“REPLY TO BIDDERS QUERIES AND AMENDMENT TO TENDER”:-

Construction of Hospital Buildings, Academic Block & Student’s Hostel with associated Services Under phase-1 for Comprehensive Redevelopment Plan for Lady Hardinge Medical College & Associated Hospitals, New Delhi :- Reply of Bidder’s queries raised during Prebid meeting held on 11/02/2011 at Lady Hardinge Medical College & Associated Hospitals, New Delhi.

CLARIFICATION / AMENDMENT No. – 2 (Civil & PHE)

WALL GUARD DETAIL

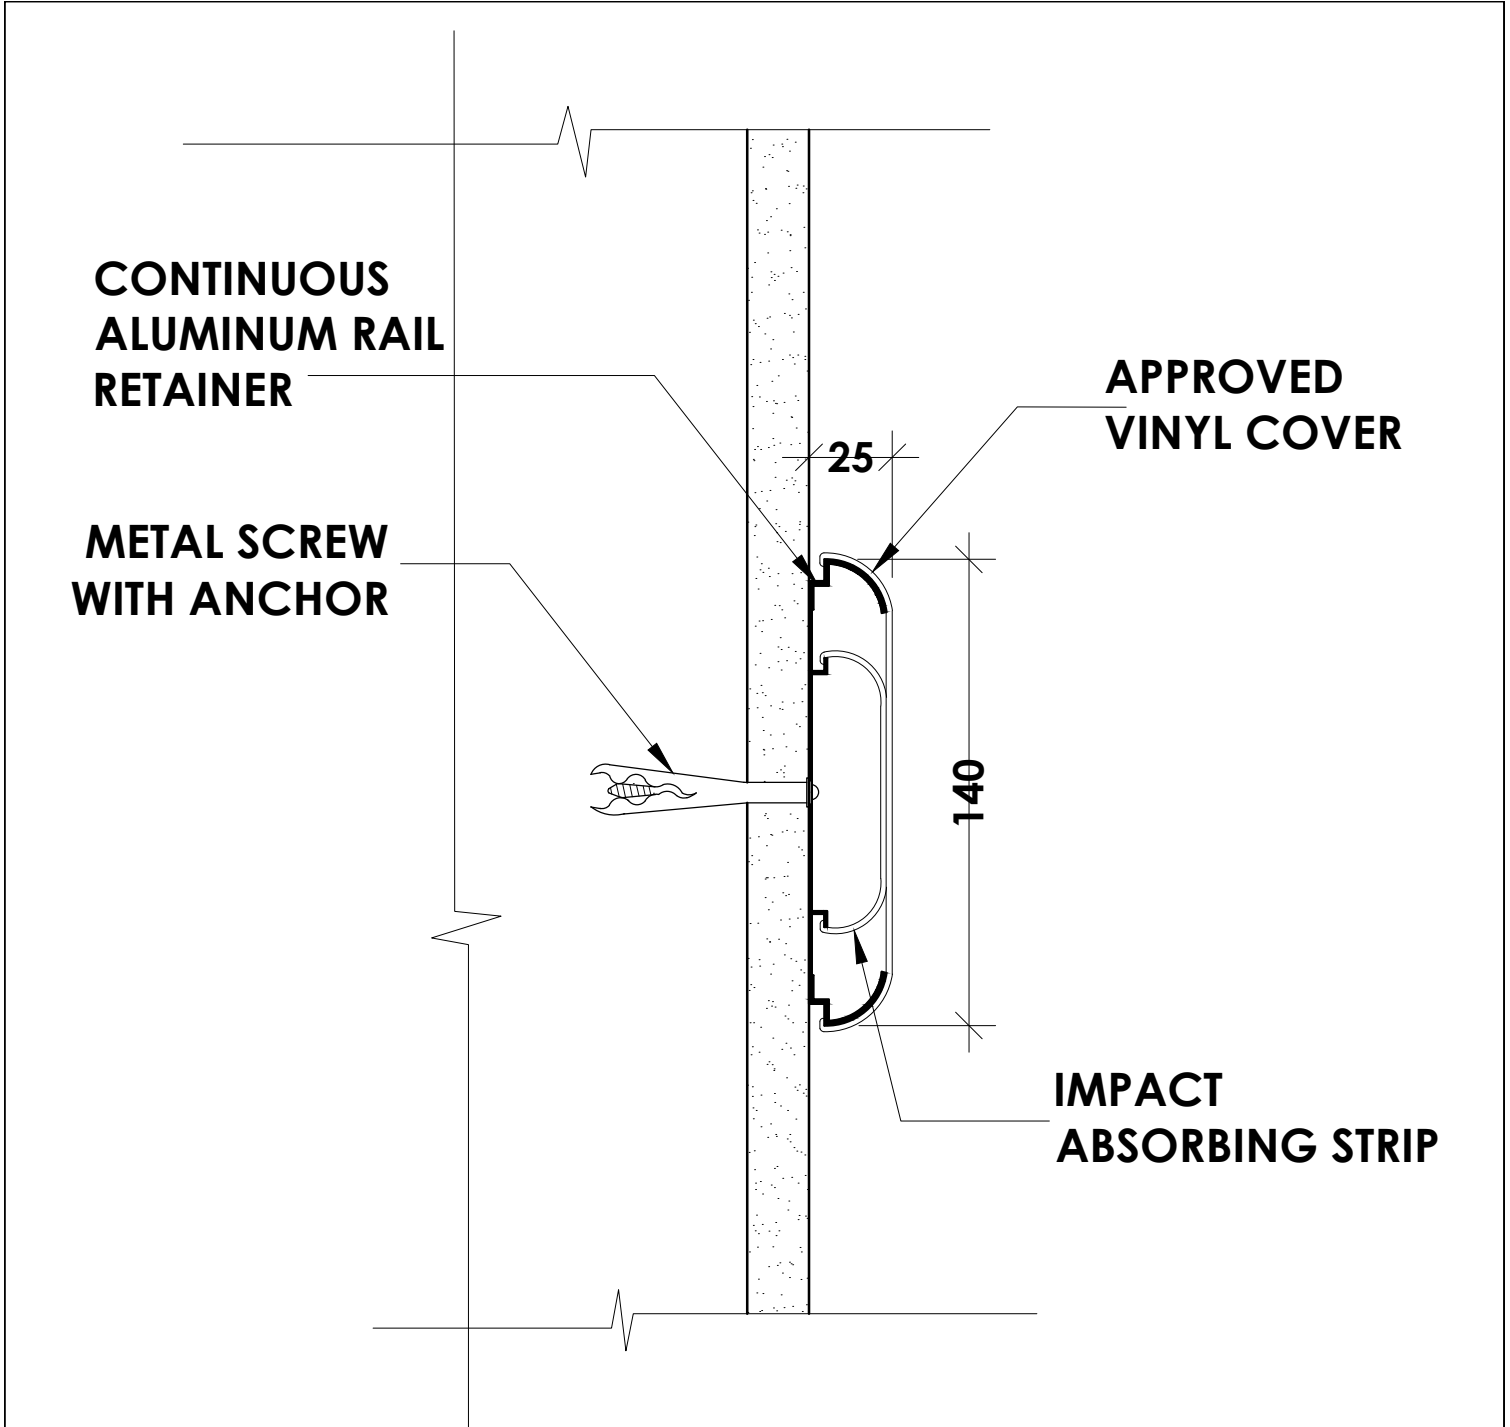
S.No.	Queries Raised	Reply
13.	BOQ Civil item No 11.14 for:-Please provide drawing and agency for Aluminium rail retainer	Refer arch drawing No DTL-01, addl drawing for rail retainer enclosed. Wherever makes have not been specified for certain items, the same shall be as per BIS and as per approval of Engineer. Kindly refer SCC Clause No 16 <u>Quality of Materials, Workmanship and Test & GCC Vol-II Clause No 28</u>
